DESIGN REVIEW COMMITTEE

January 21, 2026 6:00 PM

AGENDA

PROPOSED ELEVATIONS

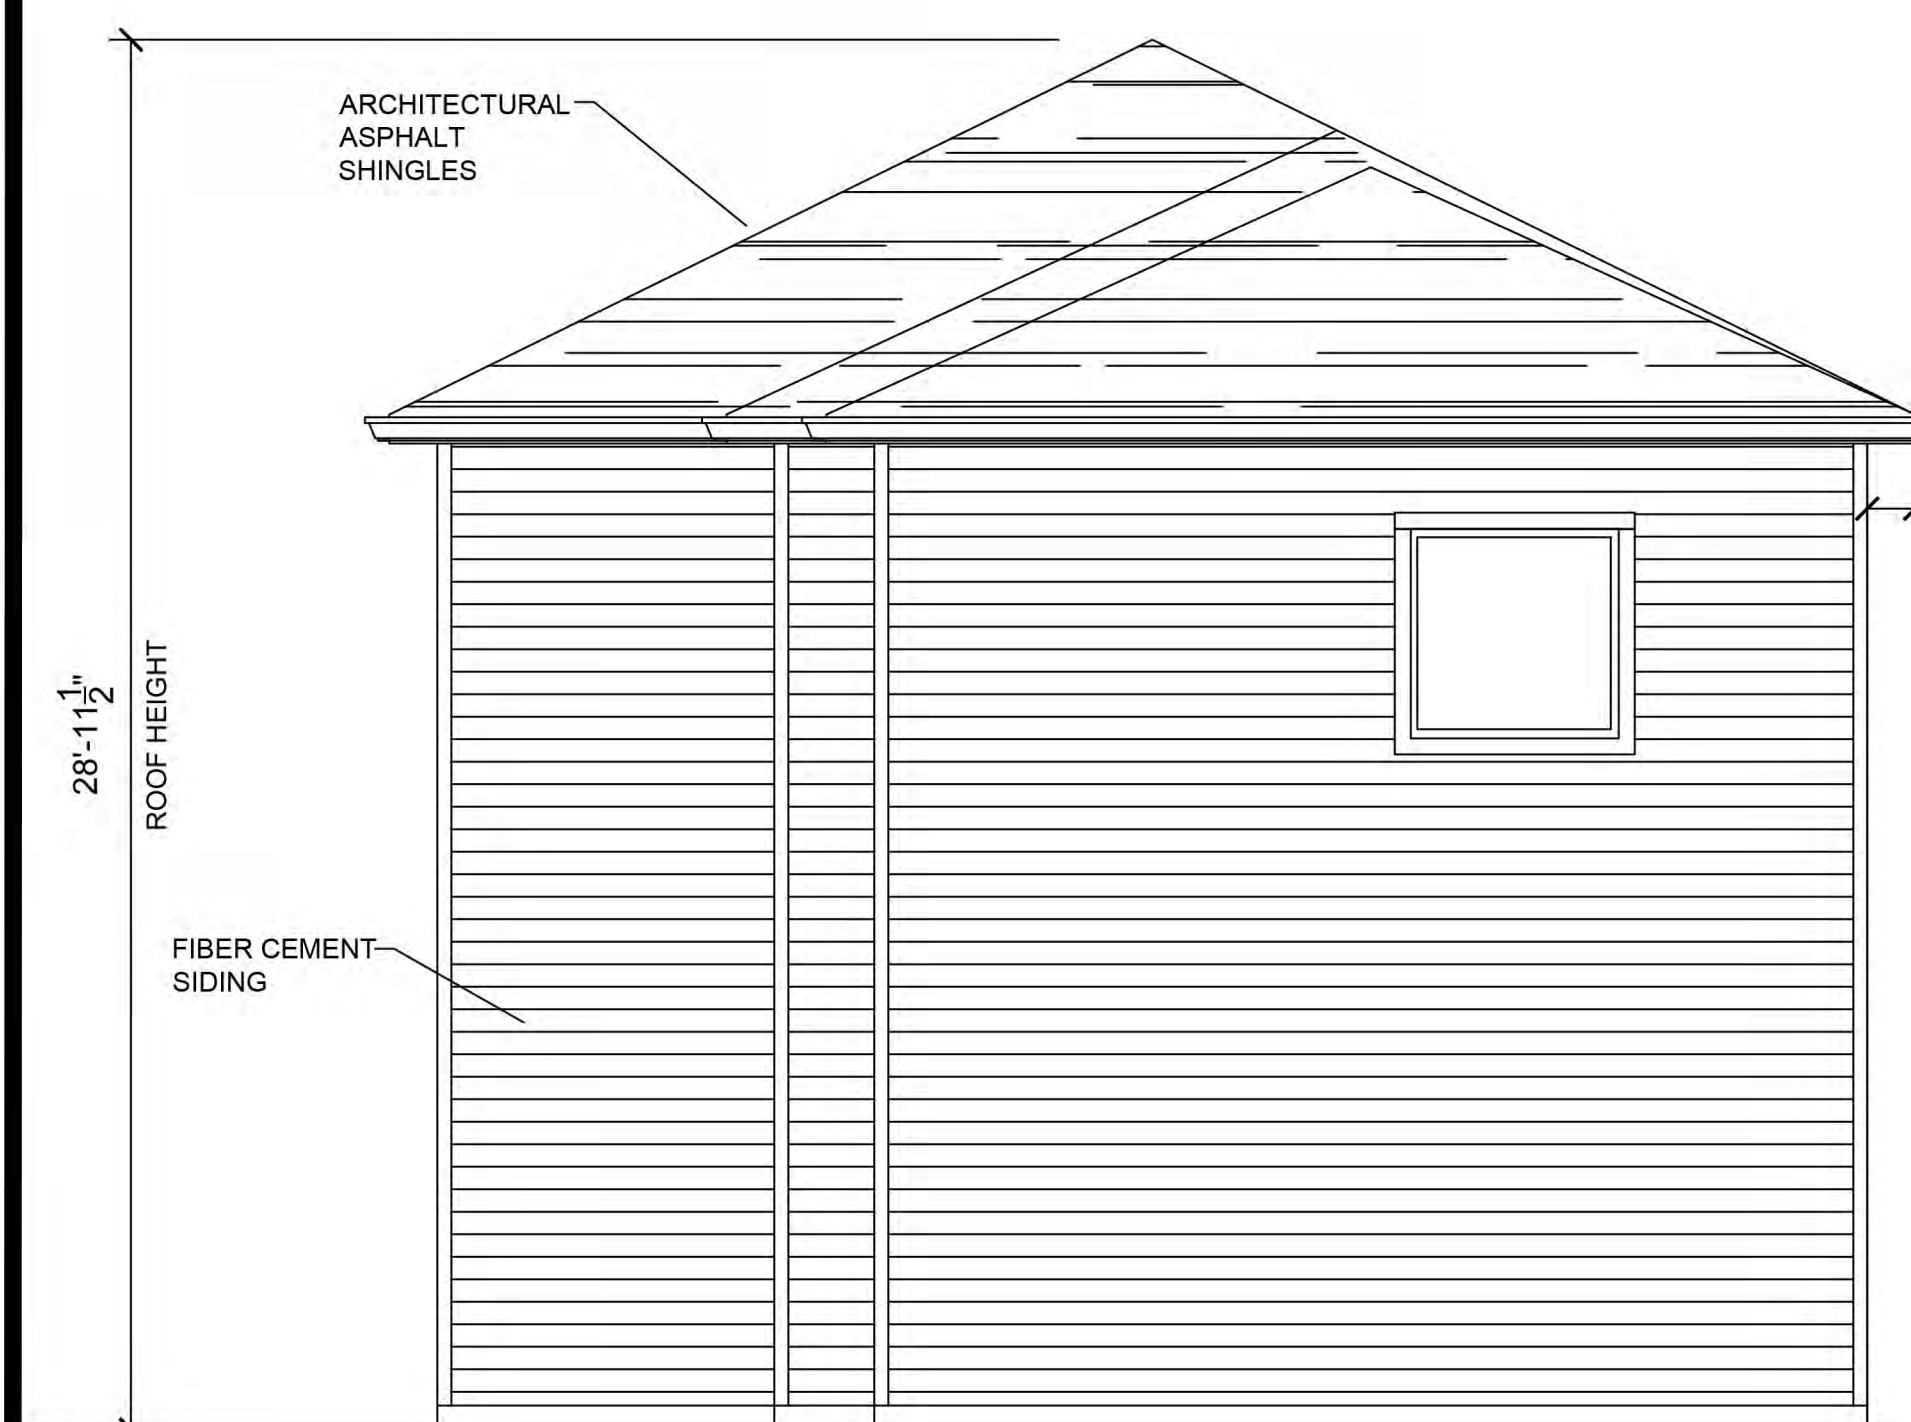
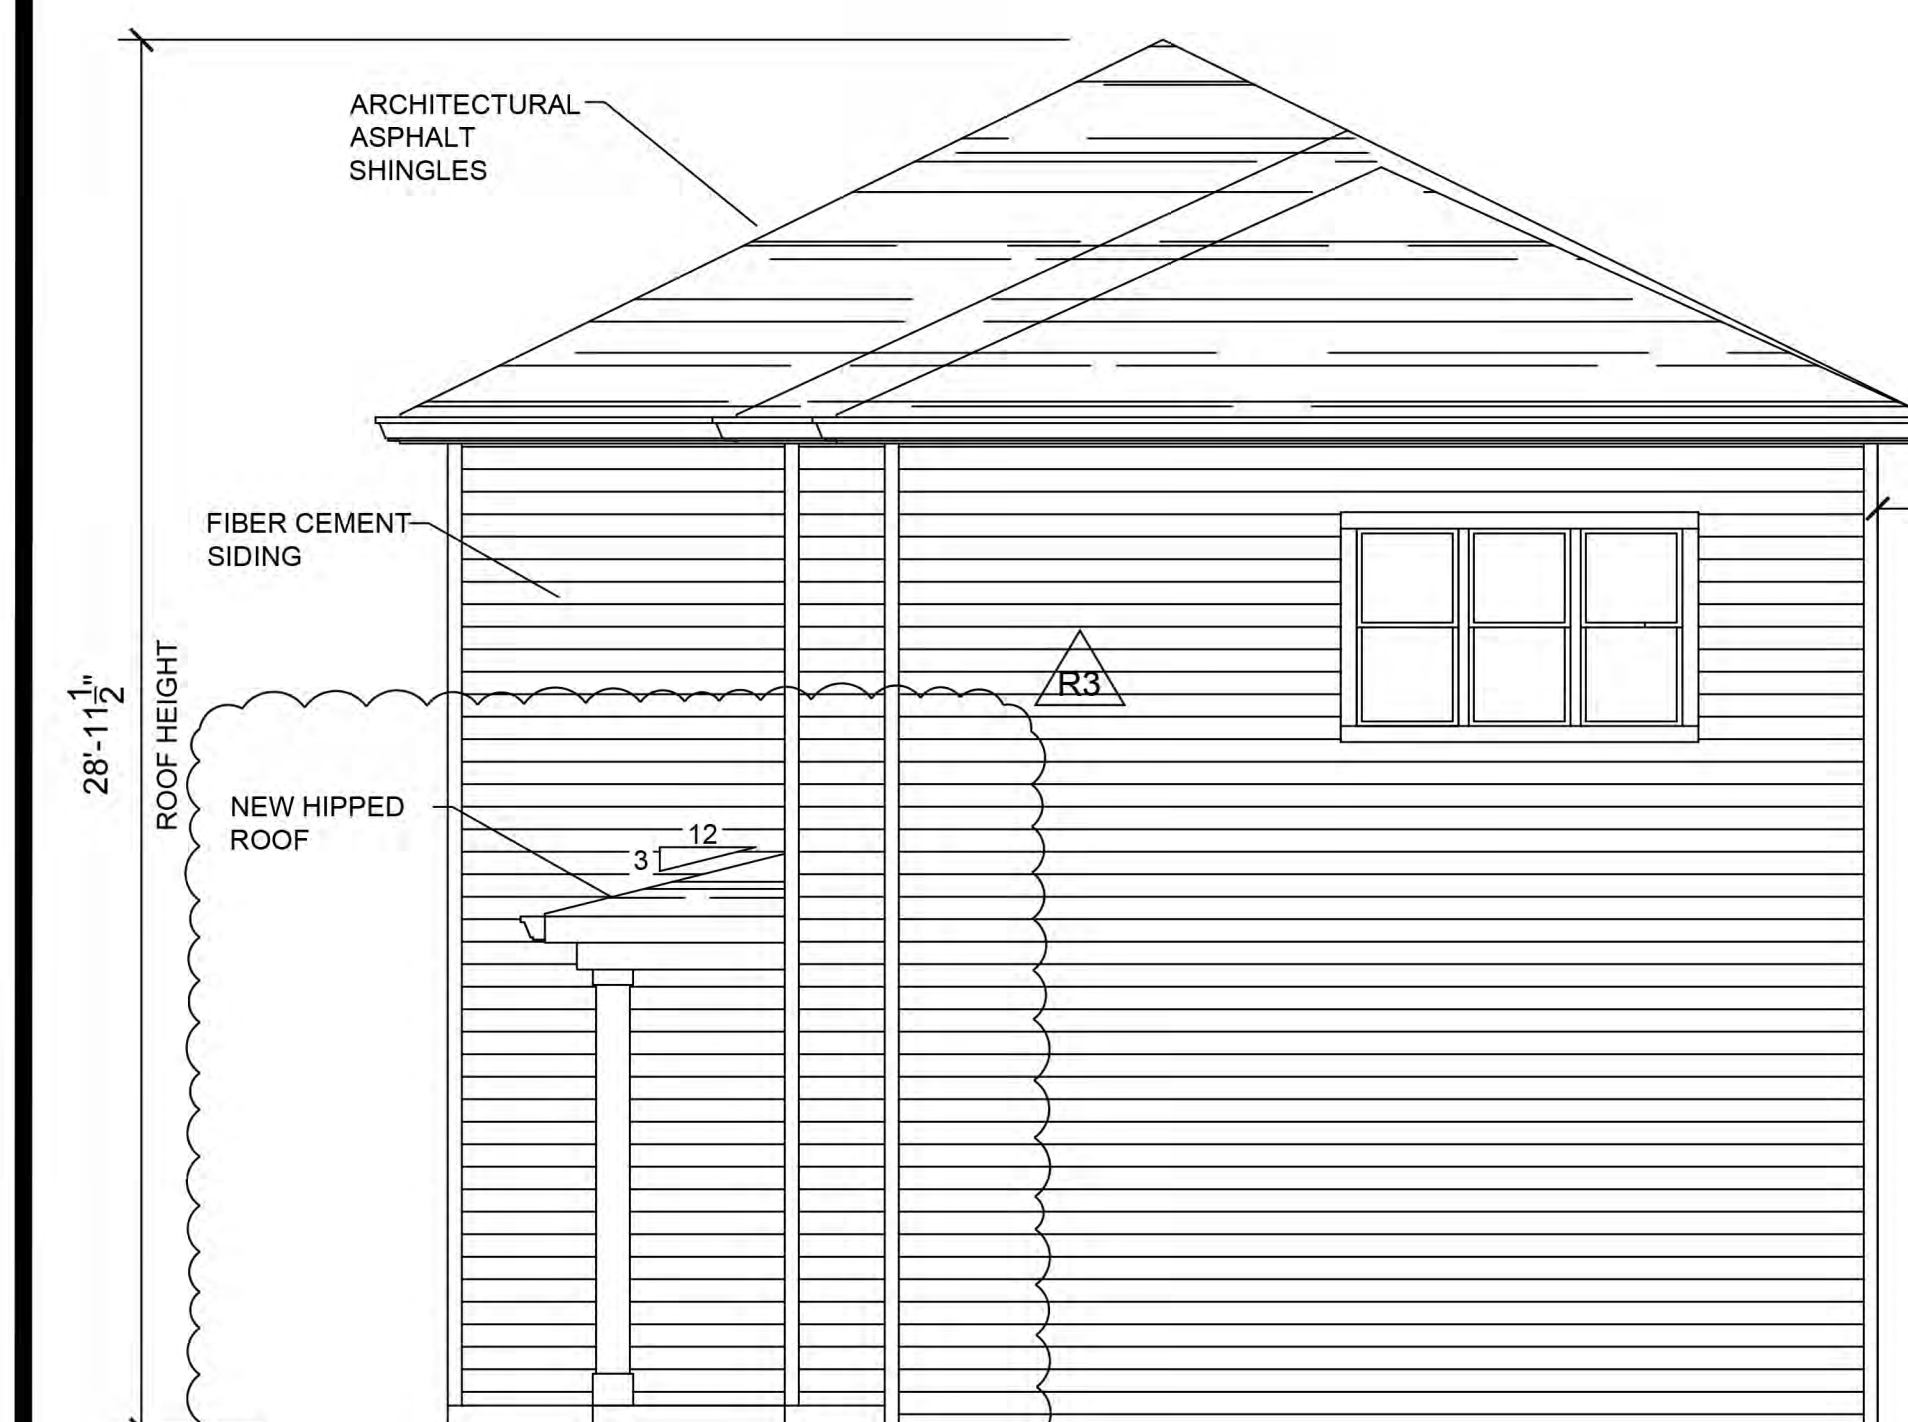
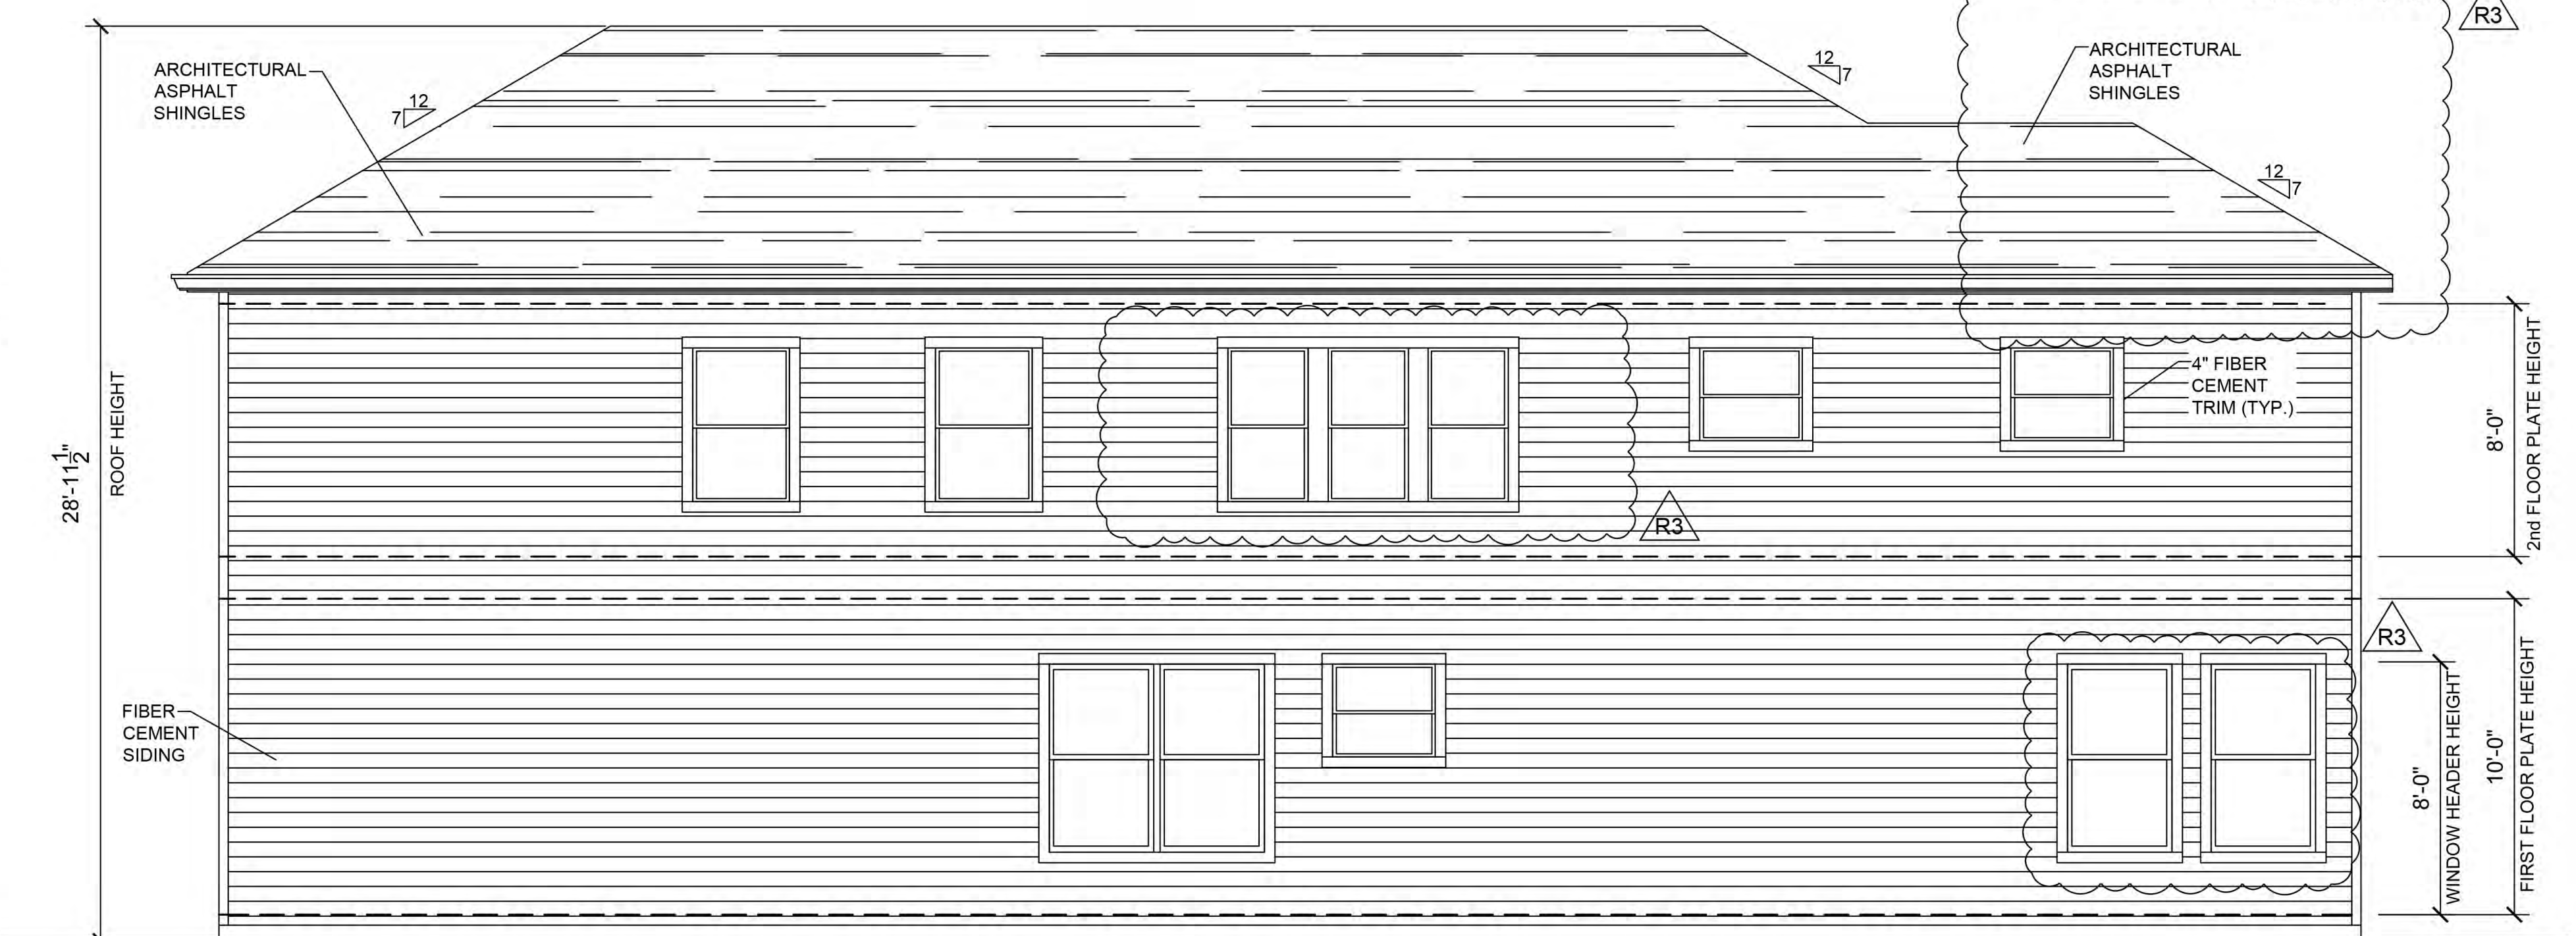
The following modifications were made to the elevations during construction to accommodate unexpected site conditions.

1. **Right Elevation:**

- 4ft x 4ft landing at right elevation side door with landing and hipped covered roof. This change was made in order to accommodate sloping grade at the door. The door was too high off the ground and needed a platform as soon as you walk out. There will be 2 steps to get to the ground.
- Additional windows above stairway windows at landing 2- 3/0 3/0 fixed windows.

2. **Front Elevation:**

- Second floor gabled roof turned into hipped roof to avoid tree limbs. The pitch remains the 7/12 pitch from gabled end.

3. **Left Elevation**

- Second floor additional window to allow more light into room
- Removed double window and used two single windows with 6" space in between.

4. **Rear Elevation**

- Replaced double windows in bathroom to 3- 24" x 48" single hung windows
- Show 4ft x 4ft landing with covered hipped roof.

The proposed changes are consistent with the overall design. The Committee may consider approval upon review.
